CITY OF ALBUQUERQUE

**RE: Main Event, Pan American Freeway and Vassar Drive
Grading Plan and Drainage Plan
Engineer's Stamp Date 5-07-2015 (File: G16-D149)**

DRAINAGE AND TRANSPORTATION INFORMATION SHEET

**RE: MAIN EVENT,
PAN AMERICAN FREEWAY AND VASSAR DRIVE
GRADING PLAN AND DRAINAGE PLAN
ENGINEER'S STAMP DATE 3-27-2015 (FILE:G-D149)**

ENGINEER'S SEAL  RONALD R. BOHANNAN P.E. #7868	MAIN EVENT		DRAWN BY
	PAN AM FREEWAY AND VASSAR AV.		BJF
	DETAIL SHEET		DATE
			05/06/15
 TIERRA WEST, LLC 5571 MIDWAY PARK PLACE NE ALBUQUERQUE, NM 87109 (505) 858-3100 www.tierrawestllc.com			2015015_DTB
			SHEET #
			C17
			JOB #
			2015015

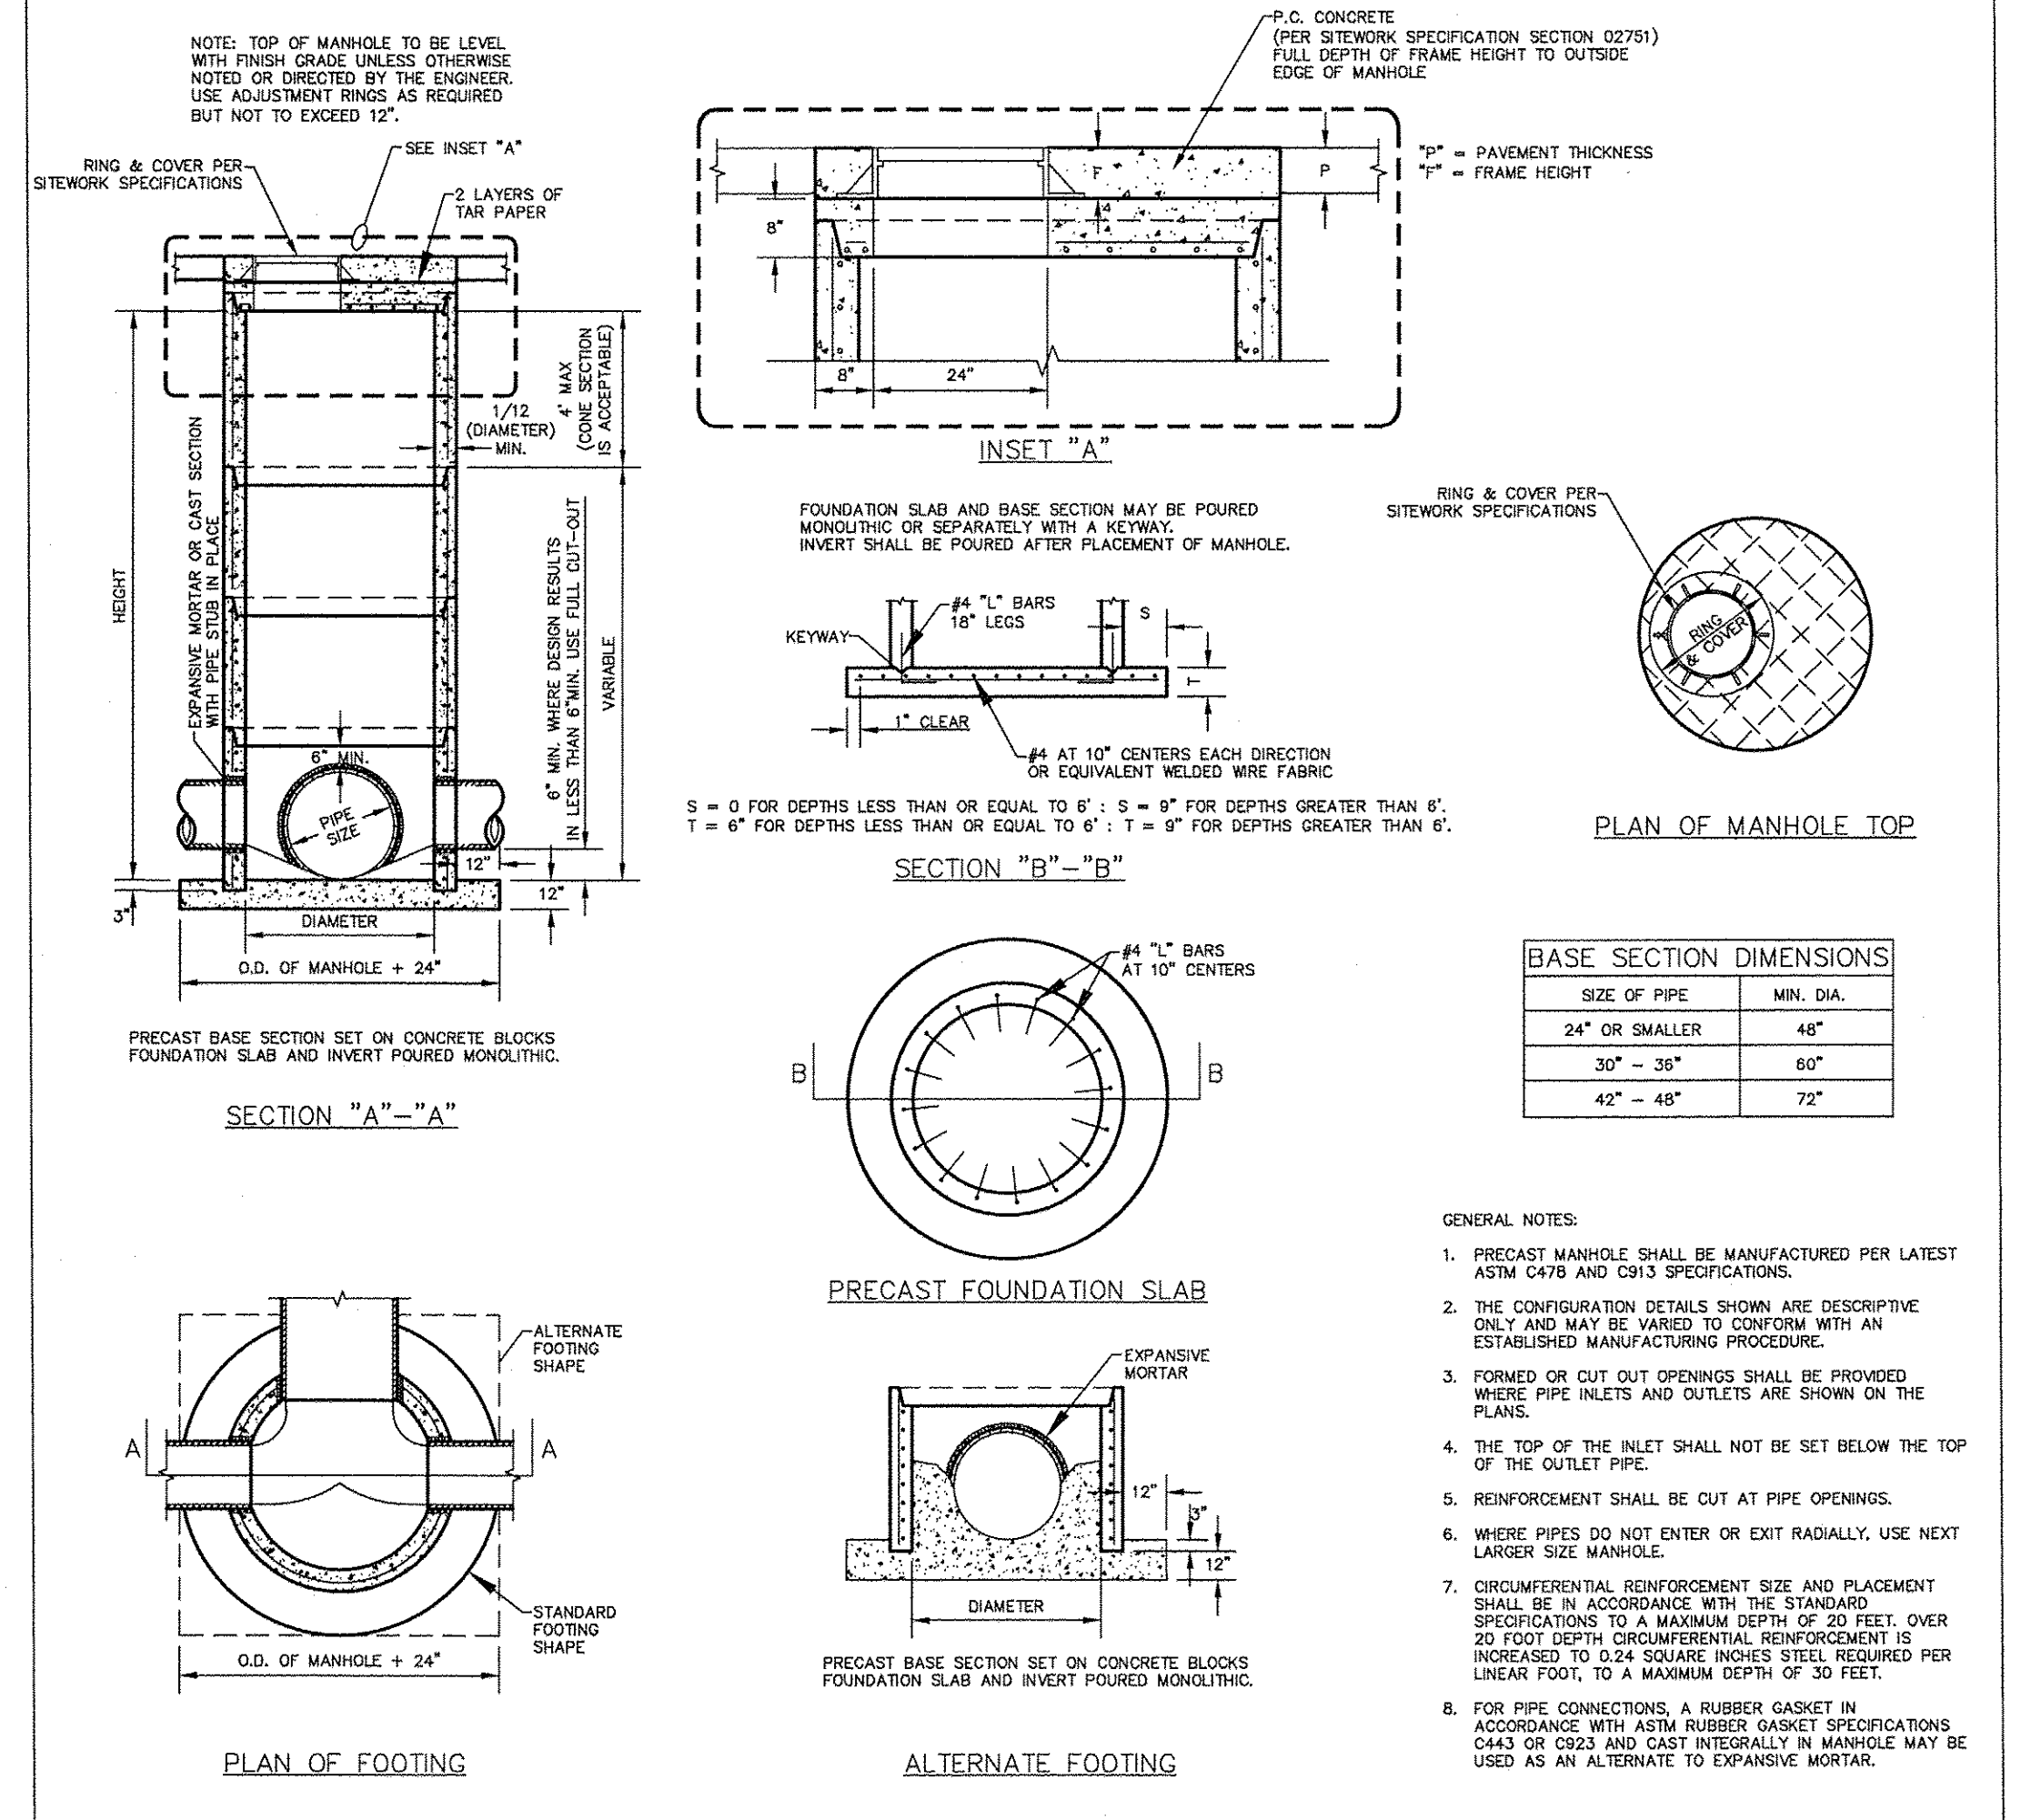
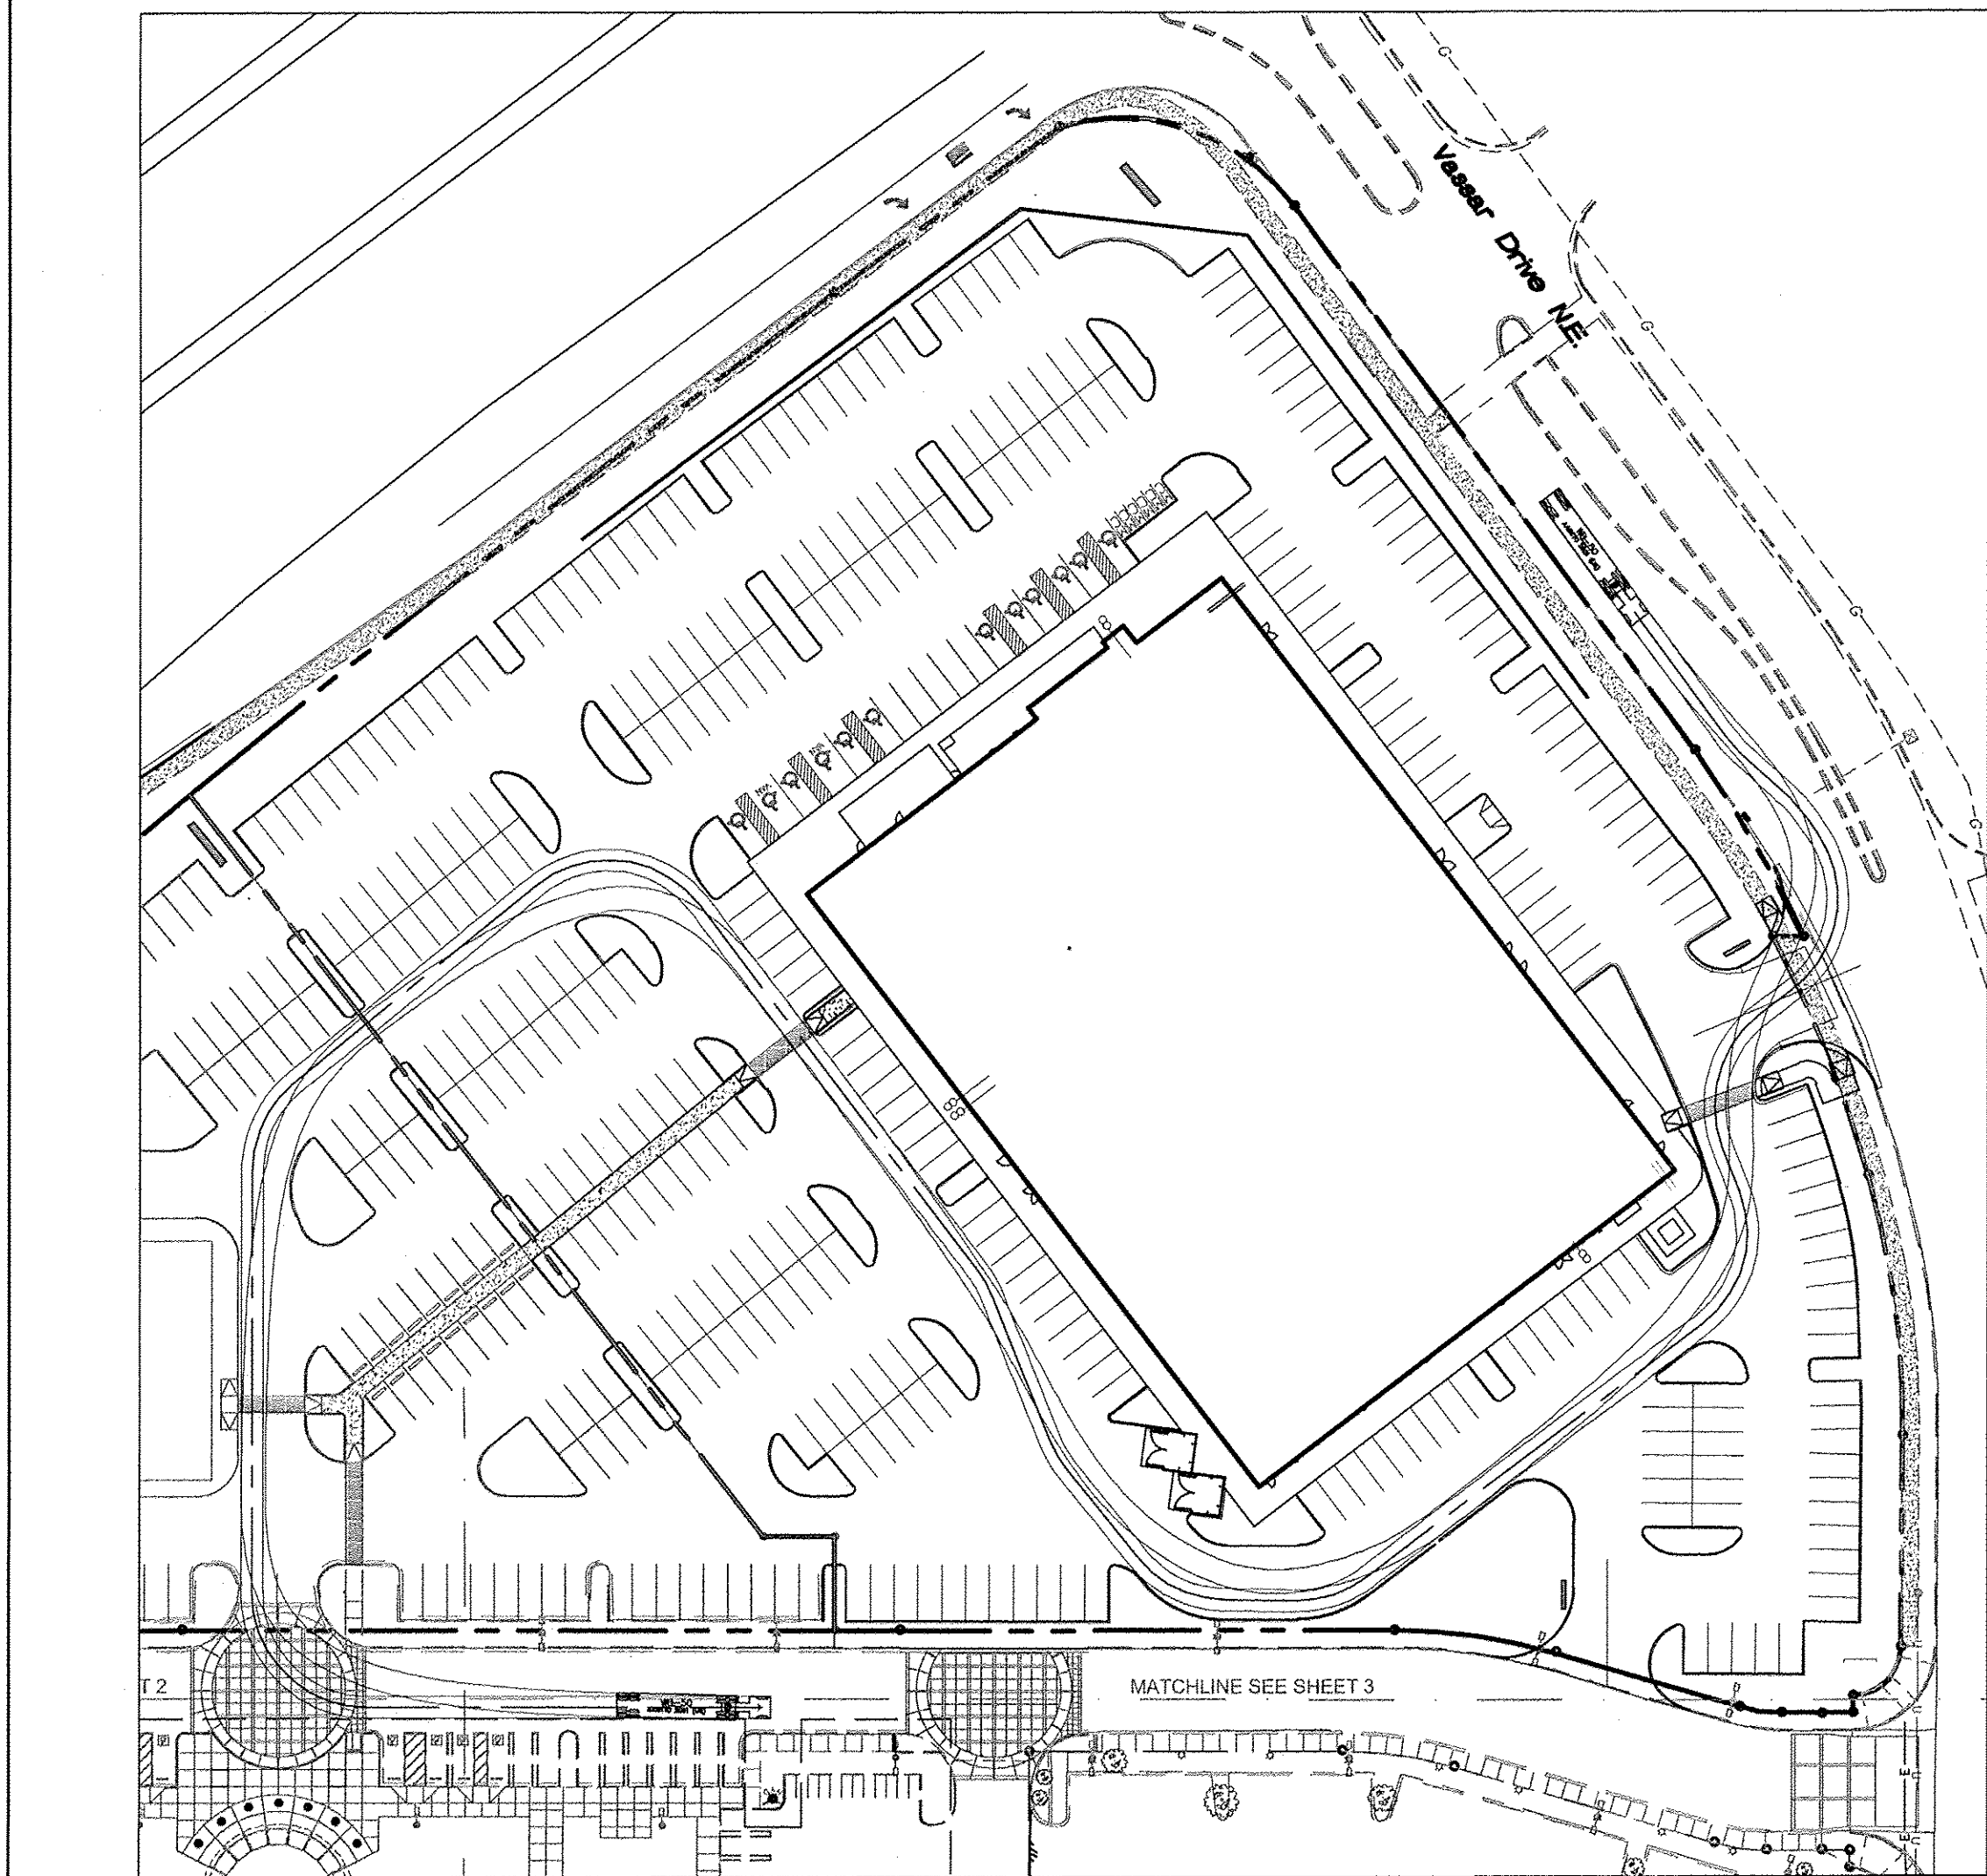
6. Include detail of the 8-foot modified manhole. **This detail was added to Sheet C17.**
